COLORADO CENTRE METROPOLITAN DISTRICT  
ADMINISTRATIVE BUILDING - SITE DEVELOPMENT PLAN  
OVERALL ALTERNATE LANDSCAPE PLAN

**COLORADO CENTRE METROPOLITAN DISTRICT**  
ADMINISTRATIVE BUILDING – SITE DEVELOPMENT PLAN  
ALTERNATE LANDSCAPE PLAN

**COLORADO CENTRE METROPOLITAN DISTRICT**  
 ADMINISTRATIVE BUILDING - SITE DEVELOPMENT PLAN  
 LANDSCAPING SCHEDULES/NOTES

LS1 SHEET ---OF

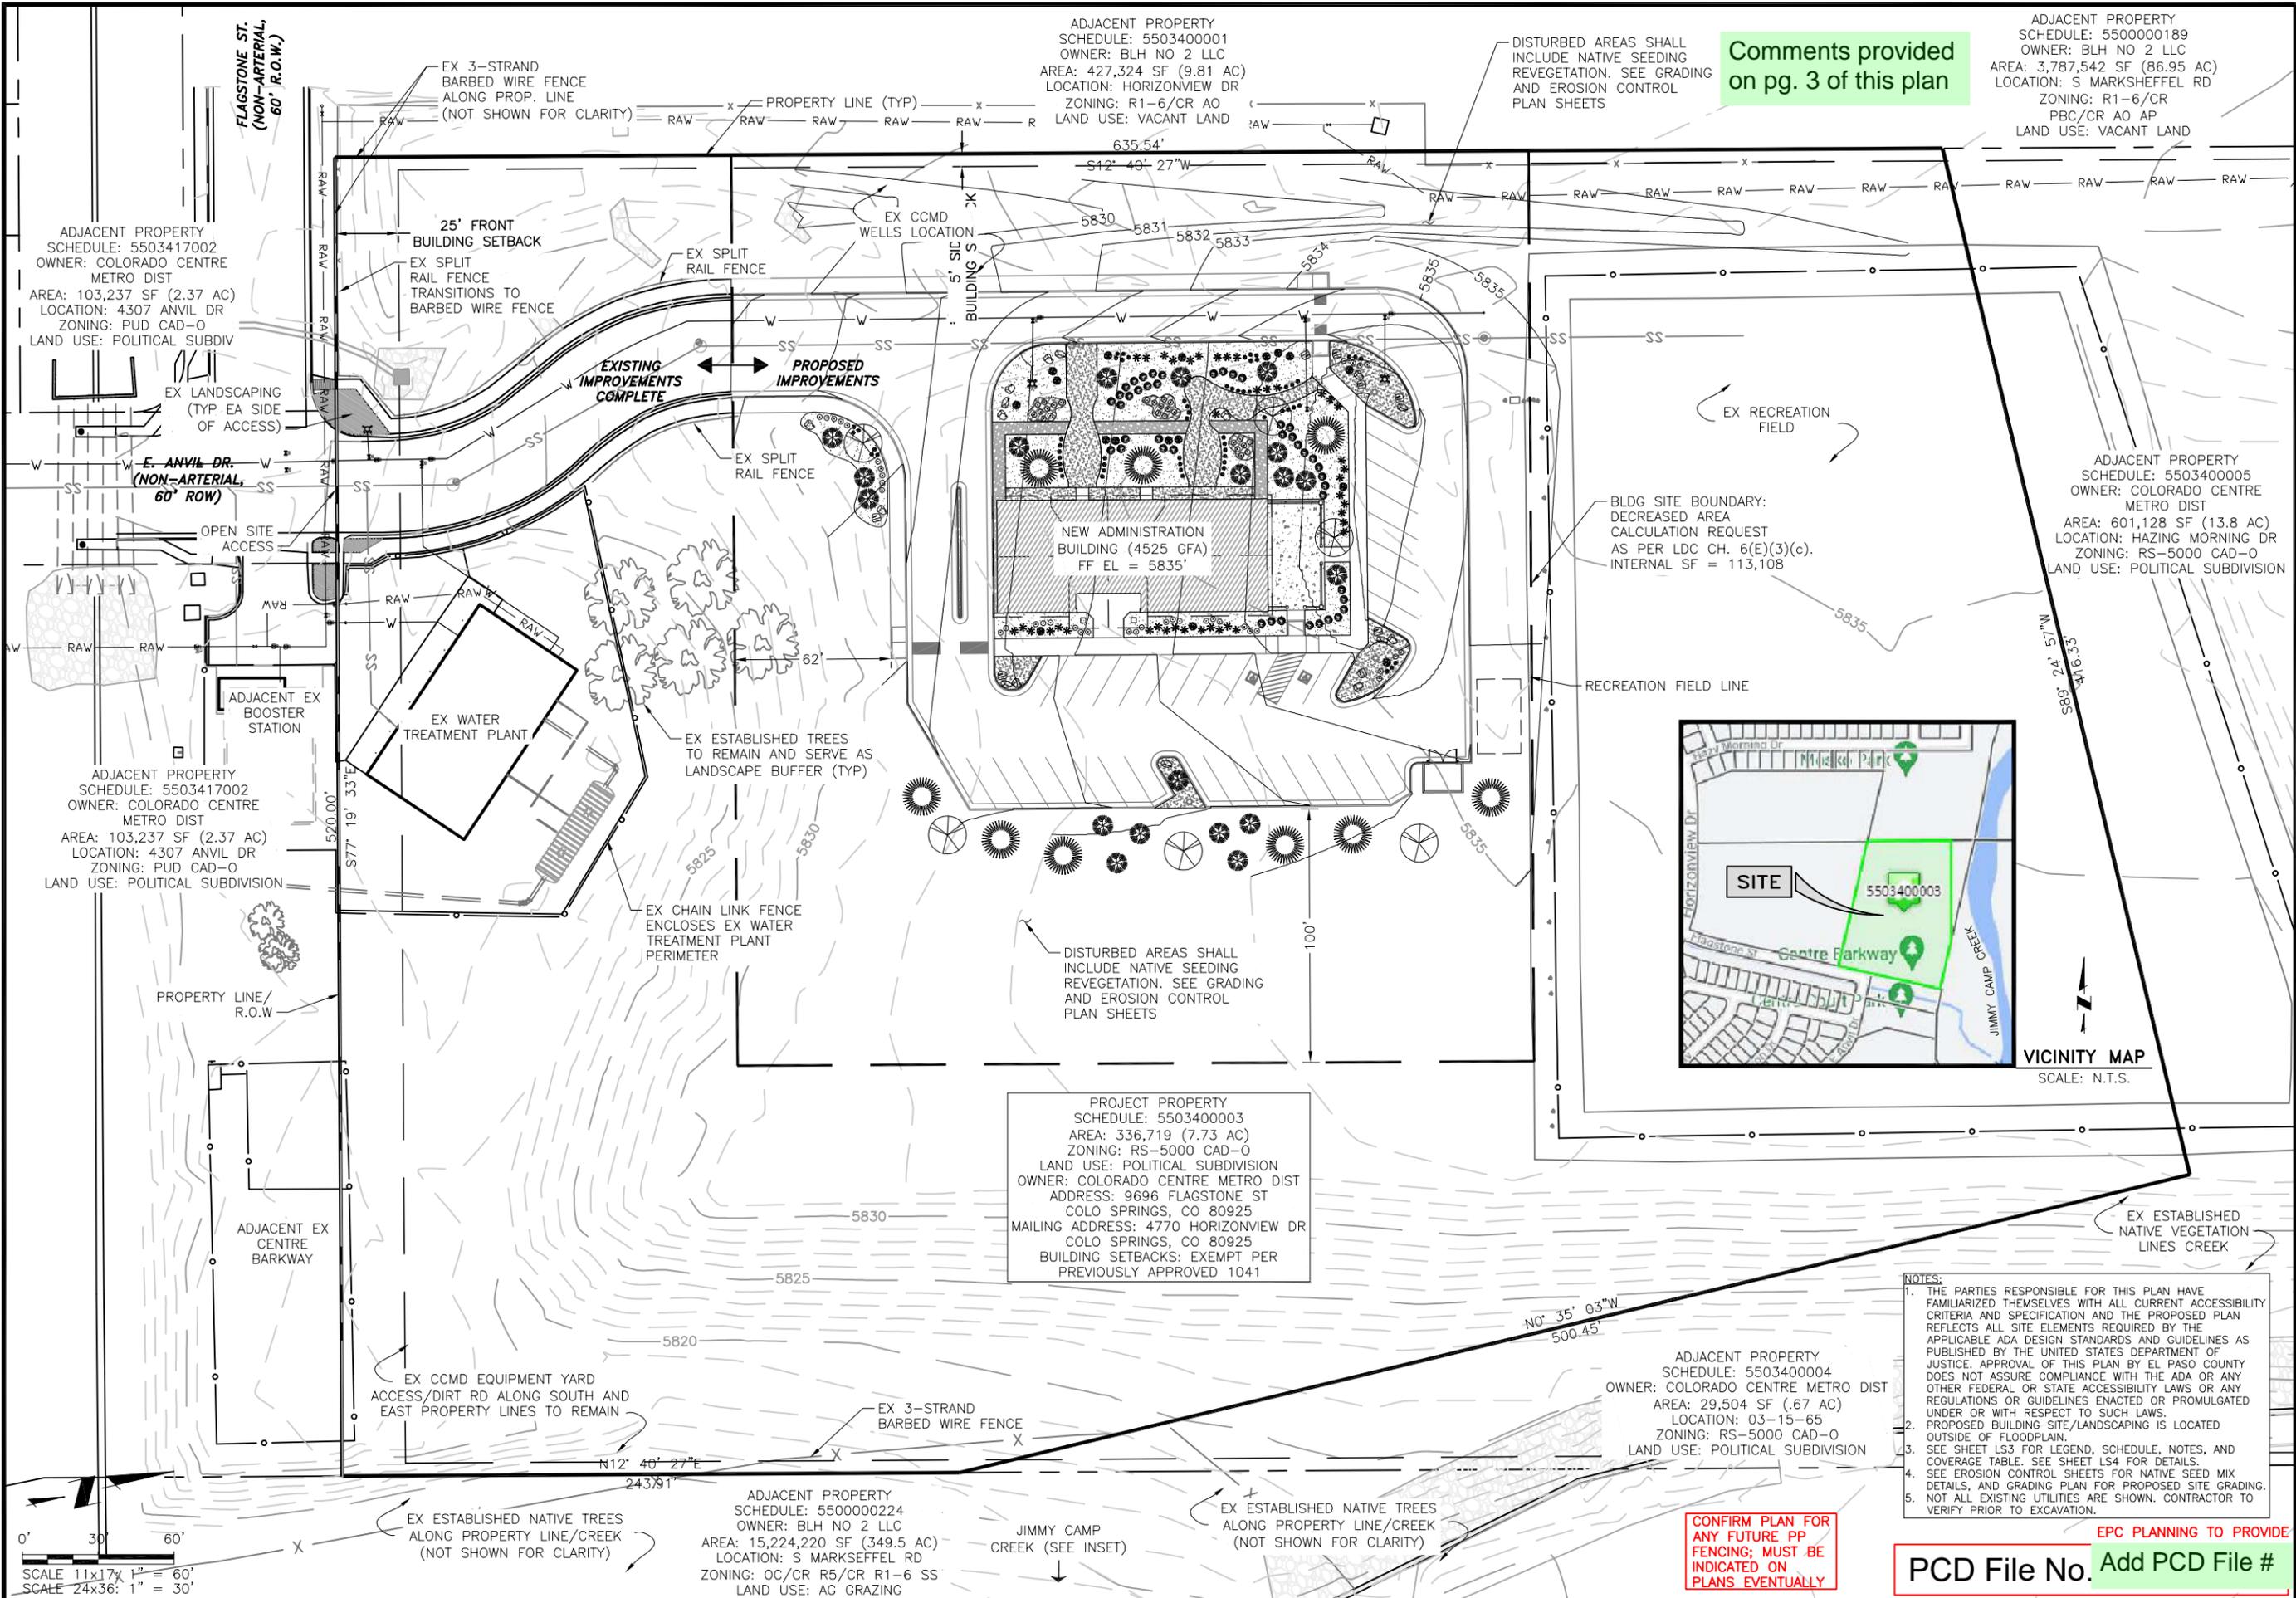
Comments provided on pg. 3 of this plan

CONFIRM PLAN FOR ANY FUTURE PP FENCING; MUST BE INDICATED ON PLANS EVENTUALLY

LS2  
SHEET --- OF ---

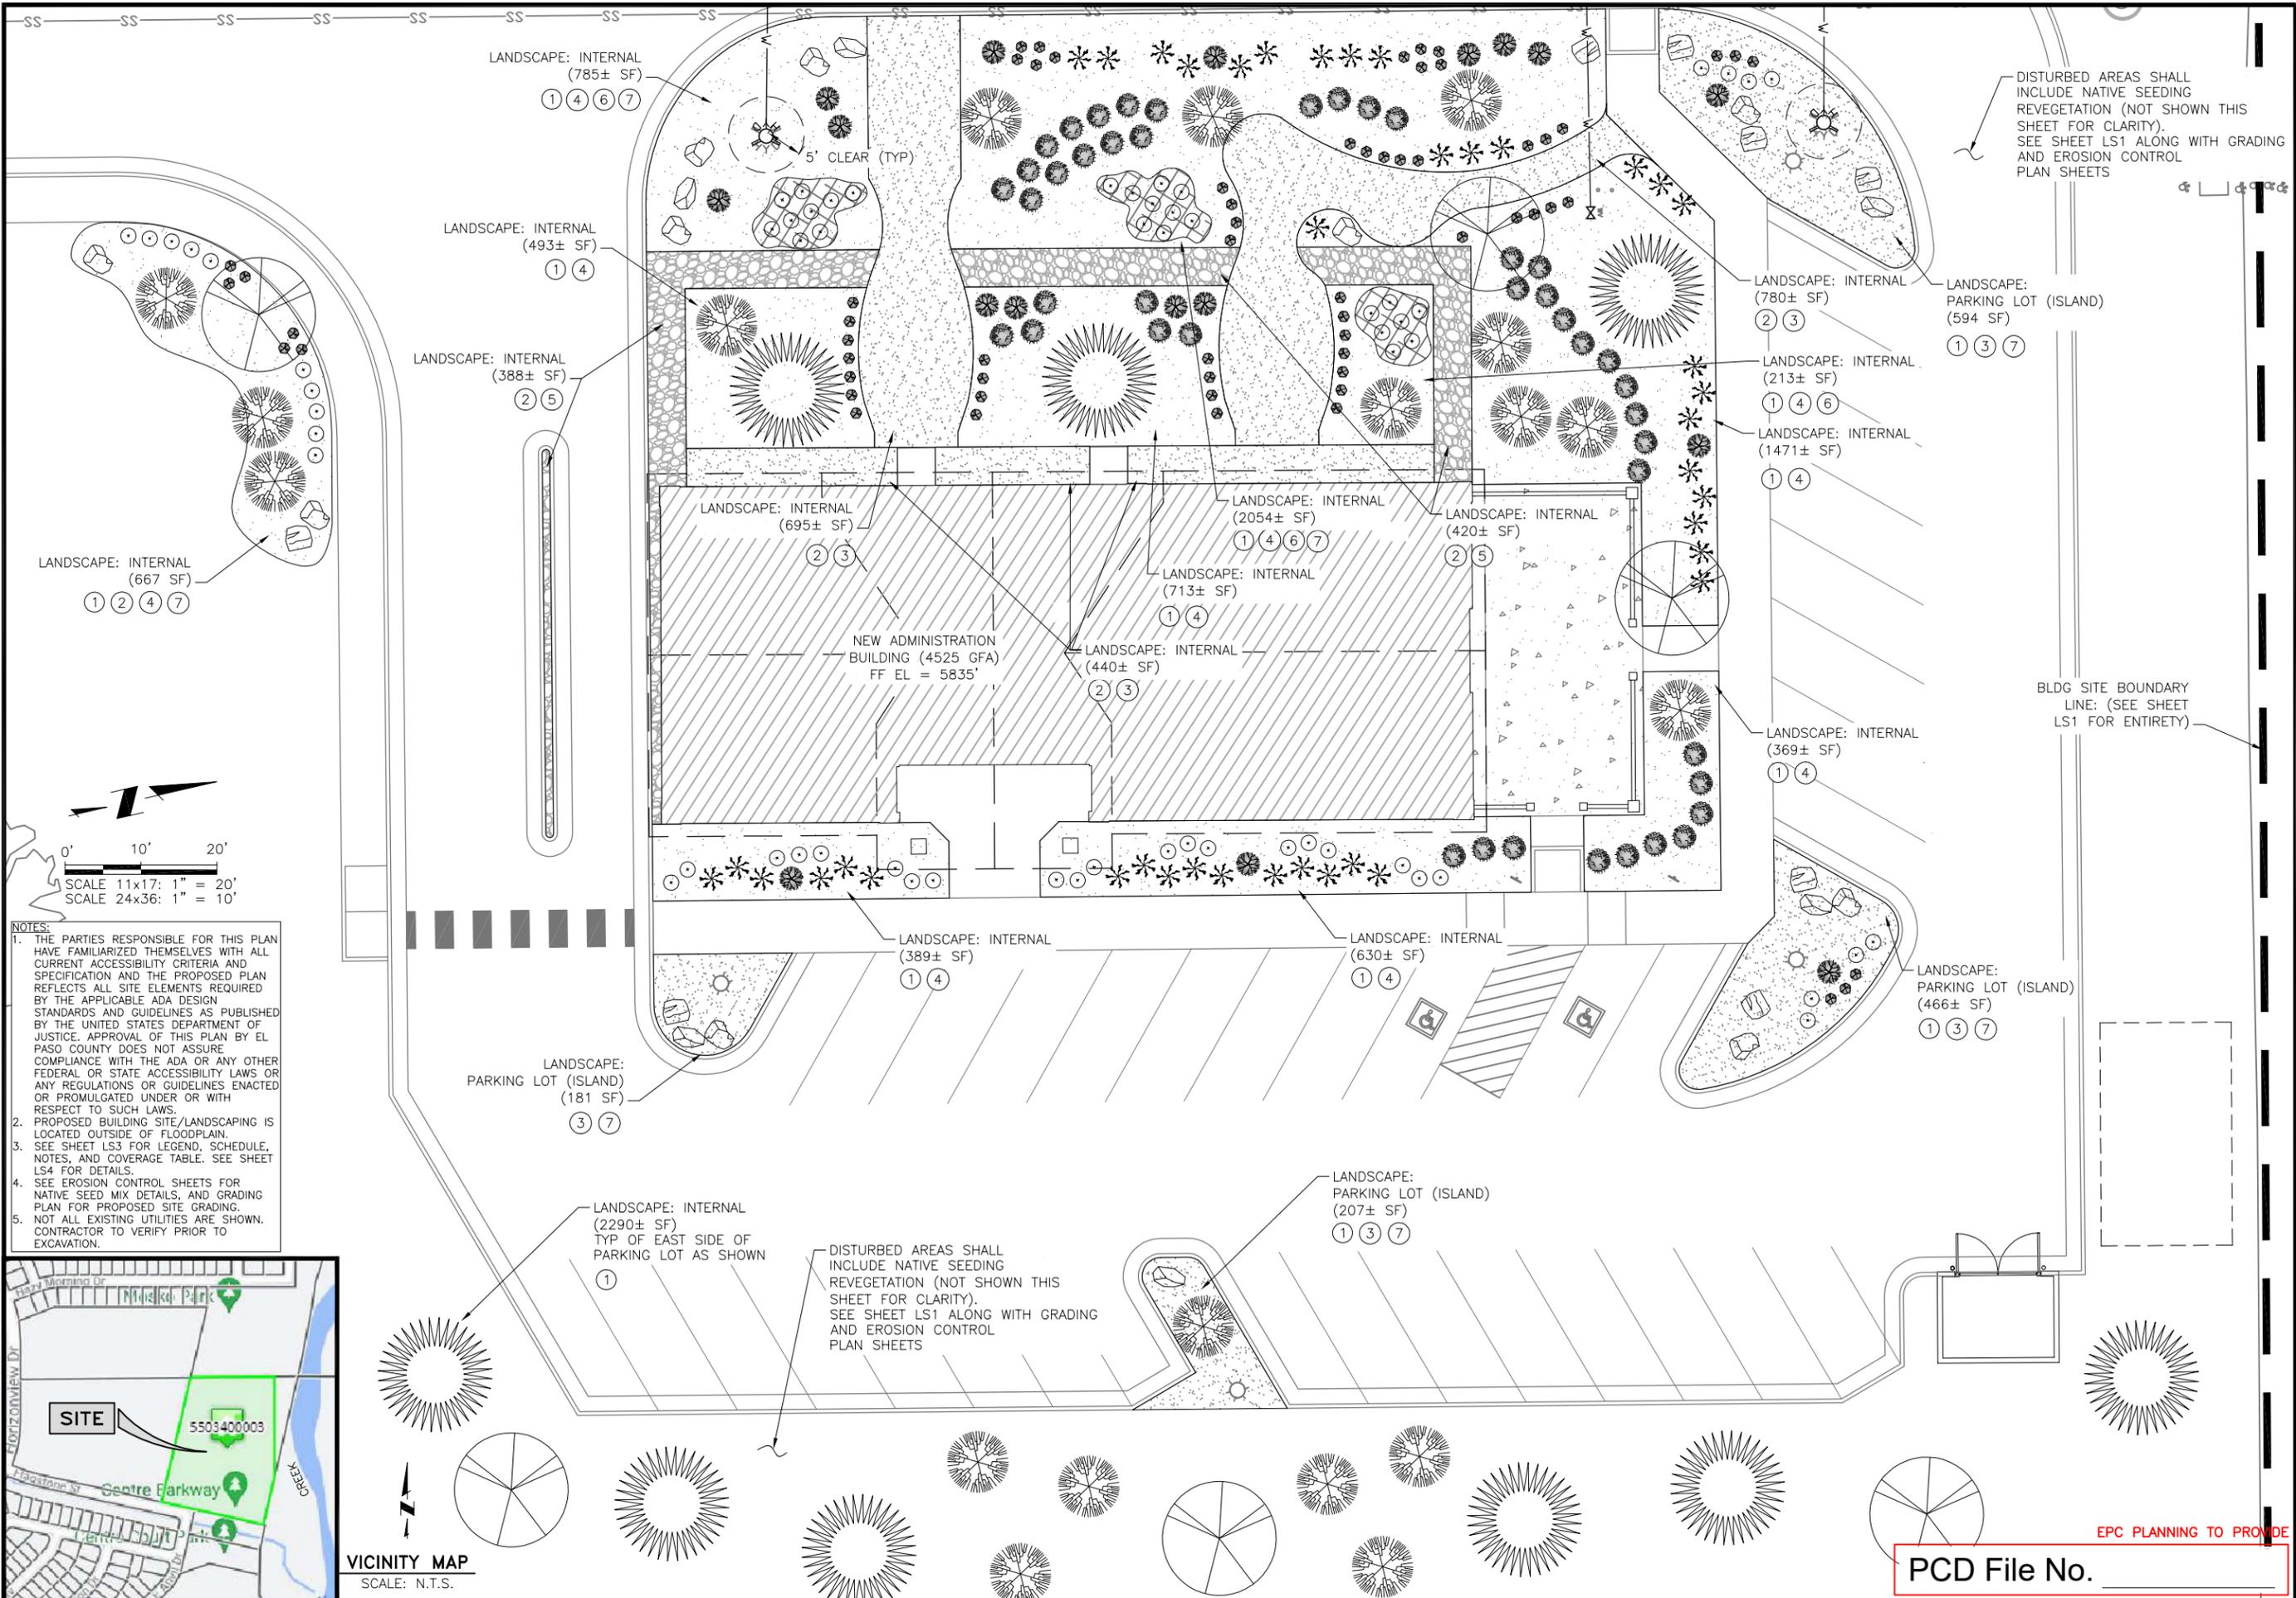
For the landscape requirements you are proposing to modify, you still need to explain what the requirement is and what you are providing.

I have counted 4 parking lot islands/fingers

Parking lot screening has not been provided per LDC Sec. 6.2.2(C)(5)

Please ensure your request meets the criteria of LDC Sec. 6.2.2(A)(4): This authority shall not allow the PCD Director to eliminate the requirement for landscaping or to diminish the total landscaped area required by this Section.
